Model: Cover Interposer Tray CI5000	Date: 21-Nov-06	No.: RB835001e
-------------------------------------	-----------------	----------------

Subject: Cover Interposer Tray CI5000		Prepared by: T.Tadokoro	
From: PPBG QA/Service Planning Dept.			
Classification:	<input type="checkbox"/> Troubleshooting <input type="checkbox"/> Mechanical <input type="checkbox"/> Paper path <input checked="" type="checkbox"/> Other ()	<input type="checkbox"/> Part information <input type="checkbox"/> Electrical <input type="checkbox"/> Transmit/receive	<input type="checkbox"/> Action required <input type="checkbox"/> Service manual revision <input type="checkbox"/> Retrofit information

Model: Cover Interposer Tray CI5000 (B835)		Date: 17-Dec-10	No.: RB835002
Subject: Modification to prevent false detection		Prepared by: T. Komori	
From: PP Service Planning Department 1G			
Classification:	<input type="checkbox"/> Troubleshooting <input checked="" type="checkbox"/> Part information <input type="checkbox"/> Action required <input type="checkbox"/> Mechanical <input type="checkbox"/> Electrical <input type="checkbox"/> Service manual revision <input type="checkbox"/> Paper path <input type="checkbox"/>

Change: Paper feed sensor

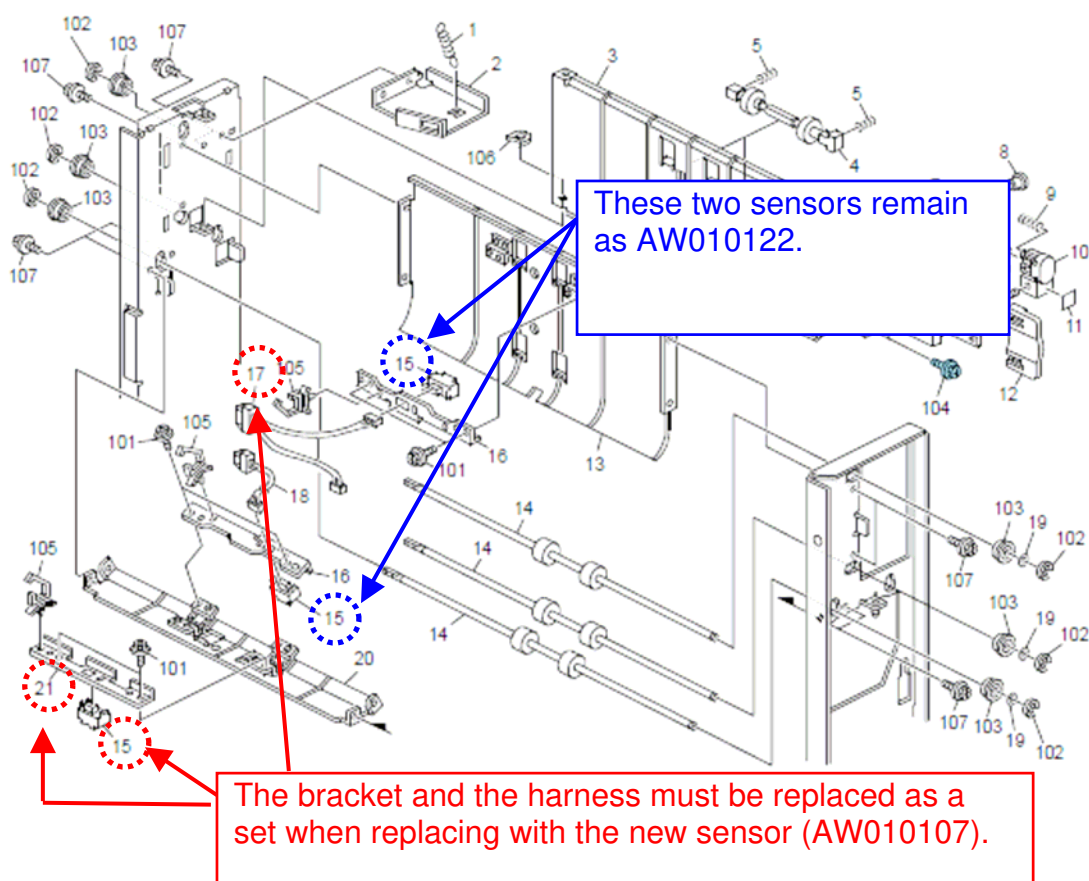
Reason: To prevent false detection

The new sensor (AW010107) can detect a wider area in comparison to the former sensor (AW010122), which will lower the chances of misdetection.

Shape of the bracket and the length of the harness have also changed accordingly with this modification.

Old Part Number	New Part Number	Description	Q'ty	Int	Page	Index	Note
	AW010107	PAPER FEED SENSOR	1	X/O	15	22	Add
B8353967	B8353966	BRACKET:SENSOR:EXIT	1	X/O	15	21	
B8355315	B8355319	HARNESS:SENSOR:ASS'Y	1	X/O	15	17

Change: Shape of the DC motor for lifting the tray

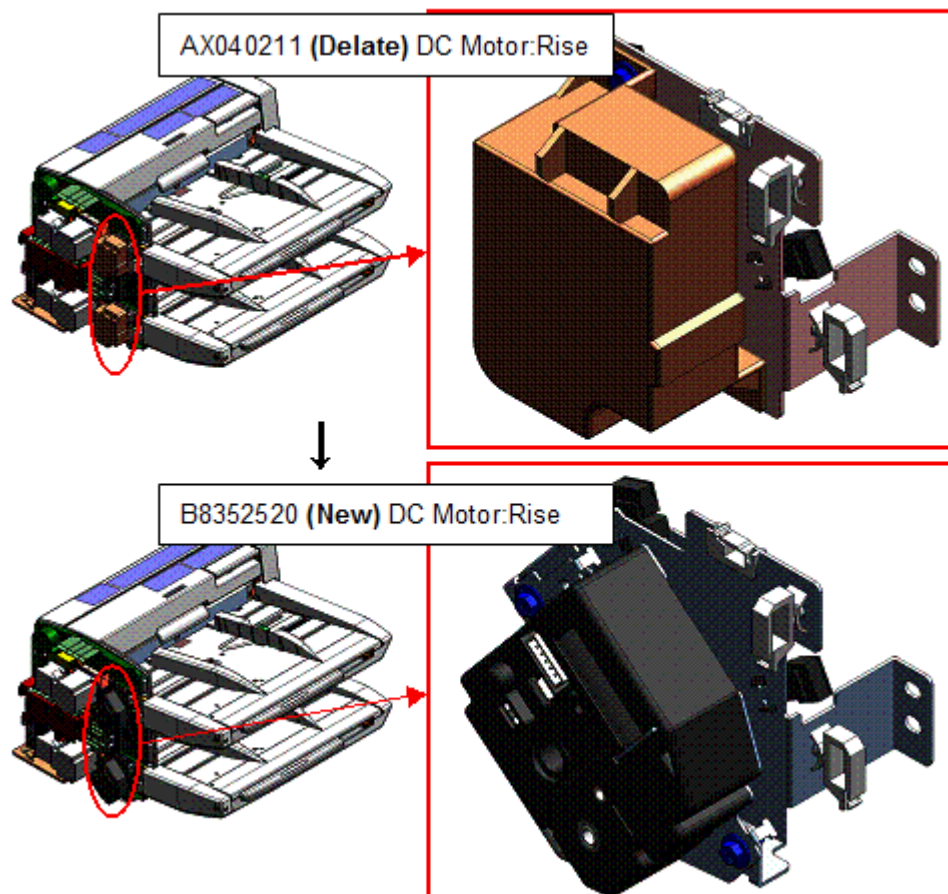
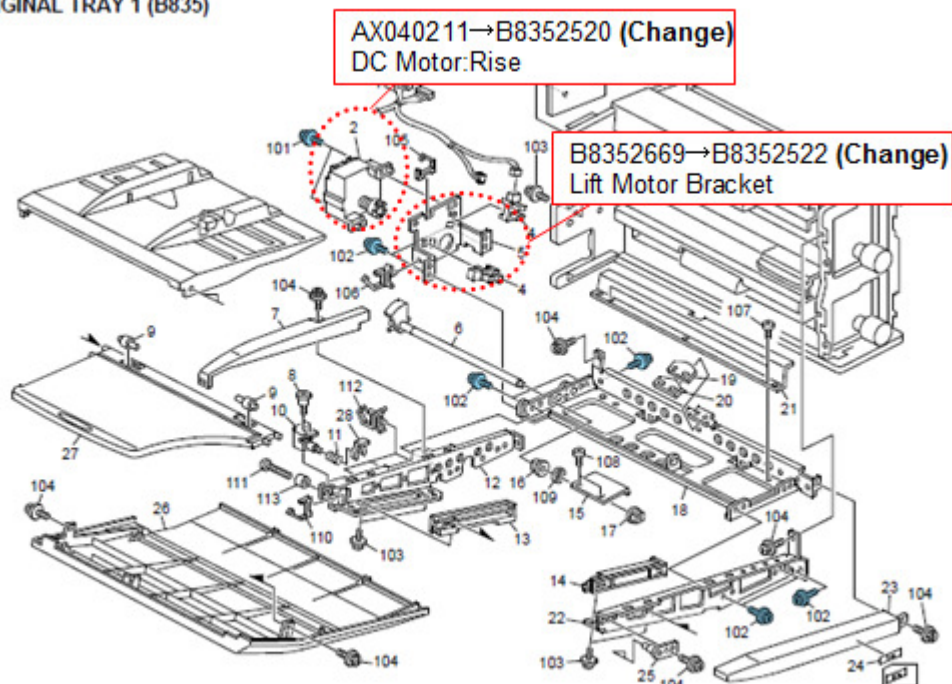
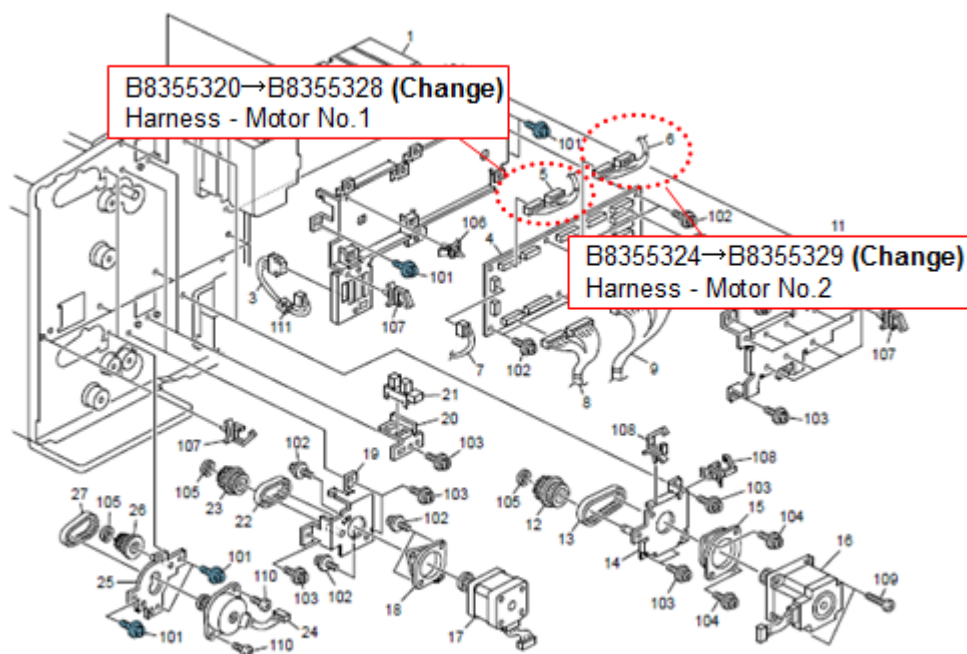
Reason: Vendor change

• When replacing these parts, replace all 4 parts as a set.

Old Part Number	New Part Number	Description	Q'ty	Int	Page	Index	Note
AX040211	B8352520	DC Motor:Rise	1	O/O	5	2	A
B8352669	B8352522	Lift Motor Bracket	1	O/O	5	5	A
B8355320	B8355328	Harness - Motor No.1	1	X/O	21	5	A
B8355324	B8355329	Harness - Motor No.2	1	X/O	21	6	A

Overview

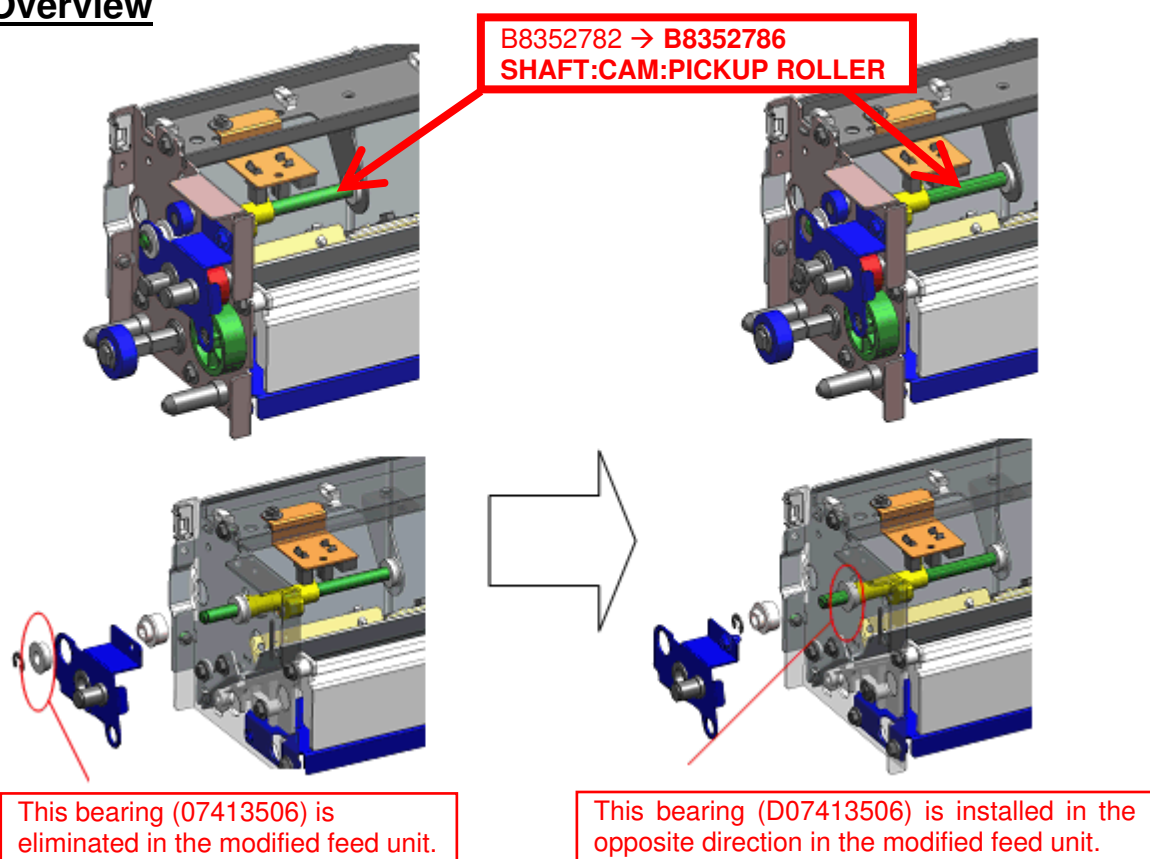
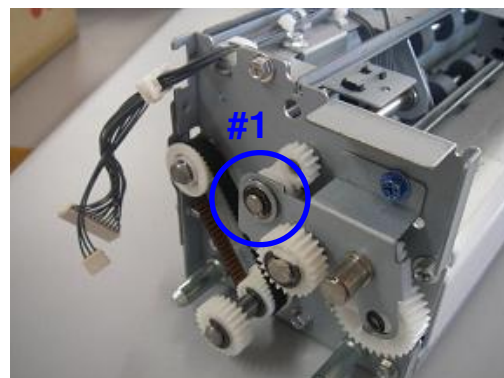
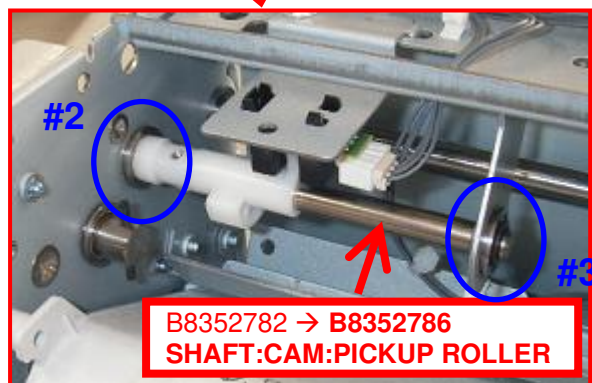
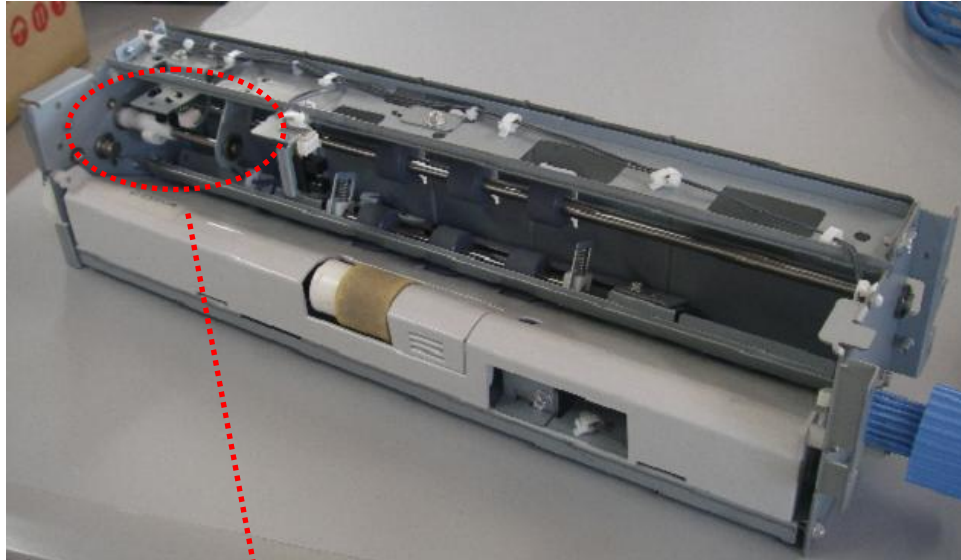
Change: The length of the cam shaft and the quantity of the bearings in the feed unit

Reason: To reduce the load on the cam shaft and the bearings

The photos below show the original feed unit before implementing the modification.

- ✓ Bearing #1 was eliminated.
- ✓ An E-ring was attached.
- ✓ The cam shaft was shortened (B8352786).
- ✓ Bearing #2 is installed in the opposite direction. (Installed from the outside of the bracket)

Old Part Number	New Part Number	Description	Q'ty	I/C	Page	Index	Note
B8352782	B8352786	SHAFT:CAM:PICKUP ROLLER	1	X/O	11	11
